Access Compliance Report

Public Rights-of-Way

Intersection ID: N/A	Main Street: WEDDINGTON_RD	Cross Street: N/A	Location: SW
ADA ID: 5610F6E5498D	Ramp Type: PerpDiag	Initial Pass/Fail: Fail	Overall Compliance: No
		Severity Score: 12.5

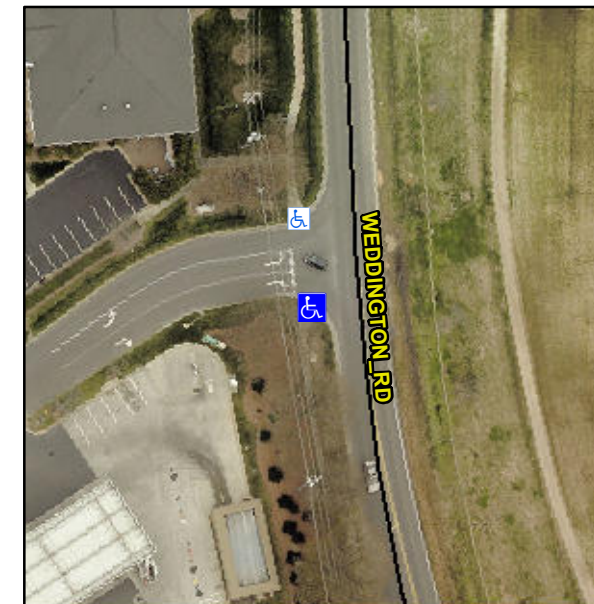
Not Found, R304.2.2

Compliance	Description	Data	Compliance	Description	Data
N/A	Ramp Length (in)	79.0	No	Ramp Slope (%)	8.7
Yes	Ramp Width (in)	48.0	Yes	Ramp XSlope (%)	0.0
N/A	Flare Type LT	N/A	N/A	Flare Type RT	N/A
N/A	Flare Slope LT (%)	N/A	N/A	Flare Slope RT (%)	N/A
N/A	Flare Traversable LT?	N/A	N/A	Flare Traversable RT?	N/A
N/A	Landing Length (in)	N/A	N/A	DWS Provided?	N/A
N/A	Landing Width (in)	N/A	N/A	DWS Contrast?	N/A
N/A	Landing Slope (%)	N/A	N/A	DWS Length (in)	N/A
N/A	Landing X Slope (%)	N/A	N/A	DWS Full Width?	N/A
N/A	Landing Curb? (Y/N)	N/A	N/A	DWS Offset (in)	N/A
N/A	Shared Landing?	N/A			
N/A	Gutter Ponding?	N/A	N/A	Gutter Slope (%)	N/A
N/A	Gutter Lip Ht (in)	N/A	N/A	Gutter X Slope (%)	N/A
N/A	Painted X Walk1?	No	N/A	Painted X Walk2?	No
	X Walk 1 Direction	To E		X Walk 2 Direction	To N
N/A	X Walk 1 Width (in)	N/A	N/A	X Walk 2 Width (in)	N/A
	X Walk 1 Slope (%)	0.8		X Walk 2 Slope (%)	0.4
	X Walk 1 X Slope (%)	0.3		X Walk 2 X Slope (%)	0.5

Remove & Replace Curb Ramp With Two New Directional Ramps or Equivalent.
